MONTGOMERY COUNTY PLANNING DEPARTMENT THE
MARYLAND-NATIONAL CAPITAL PARK AND PLANNING COMMISSION

MEMORANDUM

SUBJECT: 1. **Preliminary Forest Conservation Plan for Parcel P146, Shady Grove Metro.**
2. **Local Map Amendment No. G-875 "PARCEL P146 SHADY GROVE METRO"**, request for reclassification of a 4.26-acre parcel of land from the R-90 Zone to the PD-35 Zone for property known as Parcel 146, located at Redland Road between the CSX Railroad Tracks and Crabbs Branch Way in Derwood, Maryland.

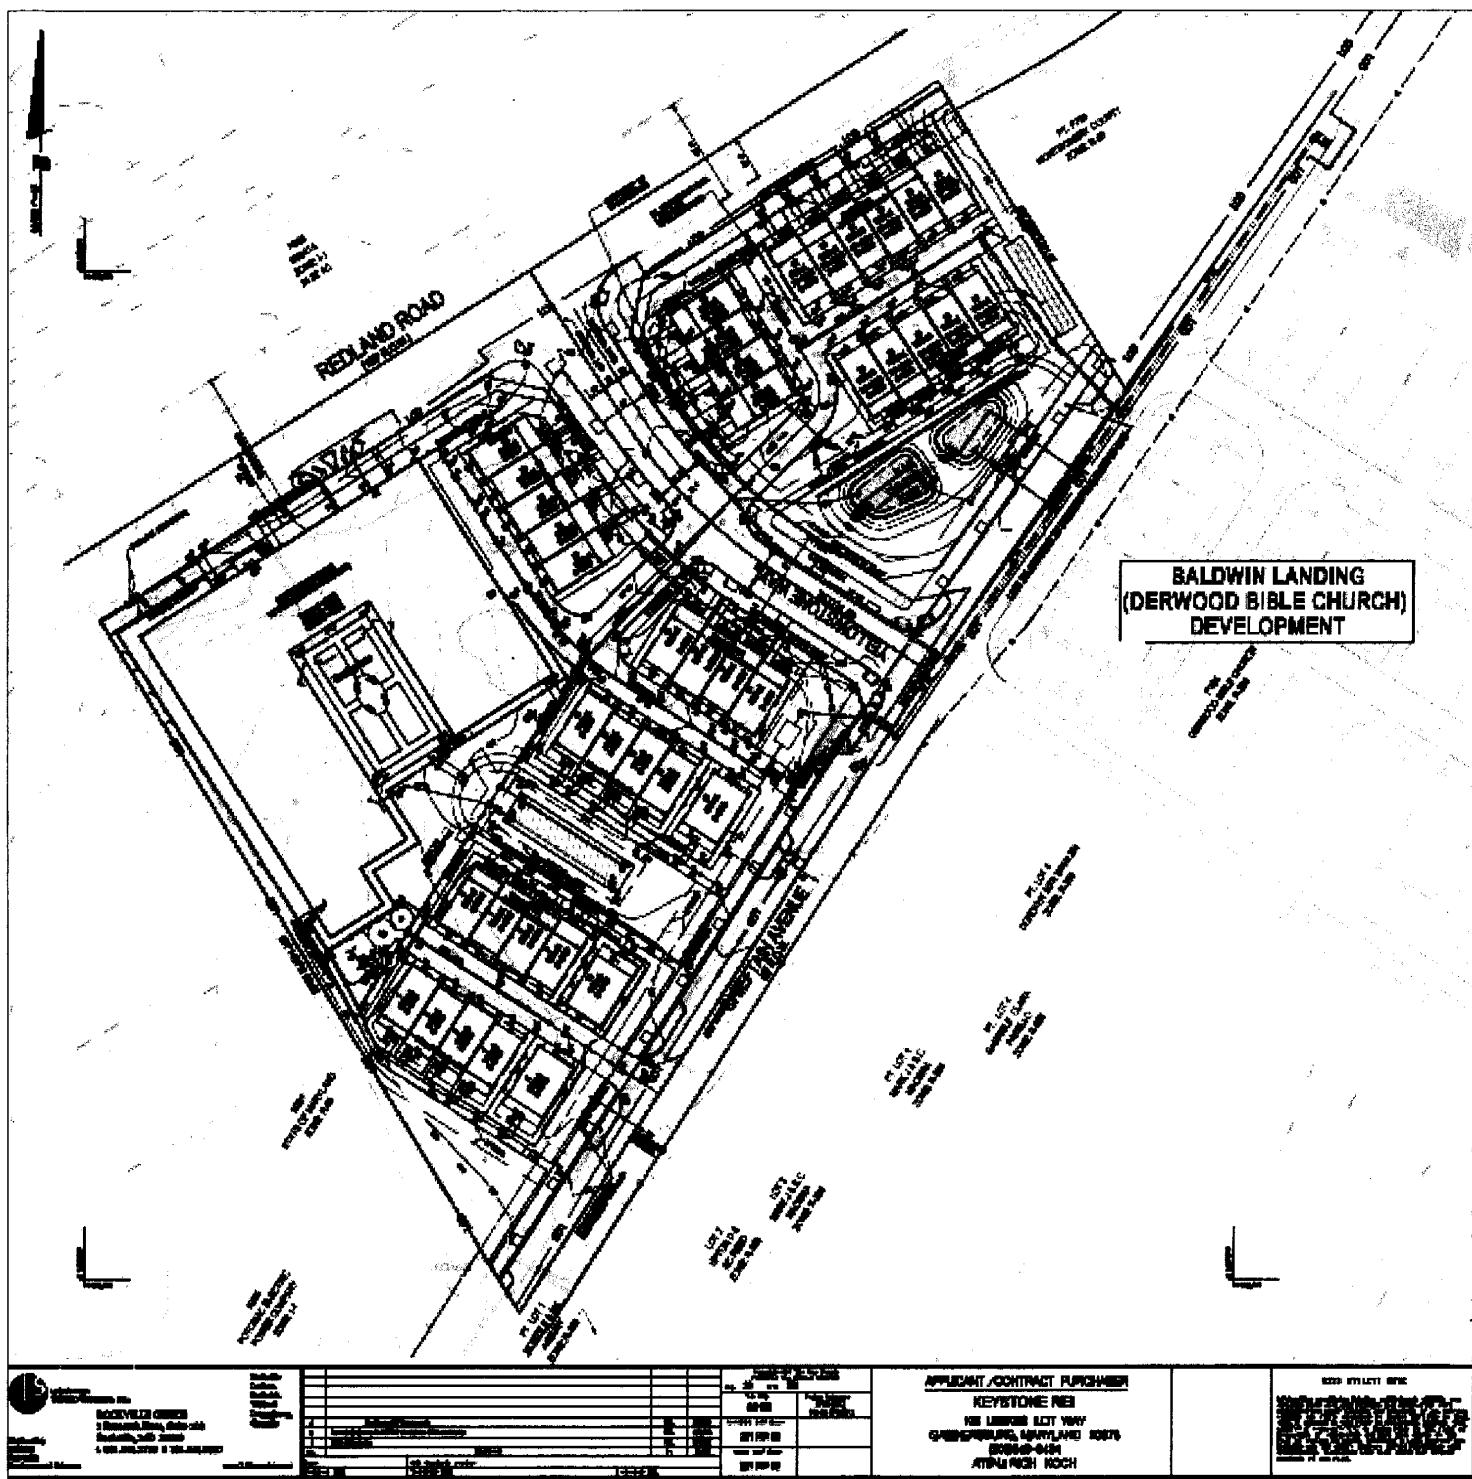
An on-site ground-level stormwater management facility with two ponds and an underground facility are shown on a revised Development Plan dated as received on February 21, 2008. All three of these facilities are located in the northeast portion of the site. Final approval of a stormwater management concept will occur in subsequent reviews. Maryland-National Capital Park and Planning Environmental Planning staff does not believe there to be any prohibitions to stormwater management facilities for the proposed high density residential uses, but the final determination will occur later.
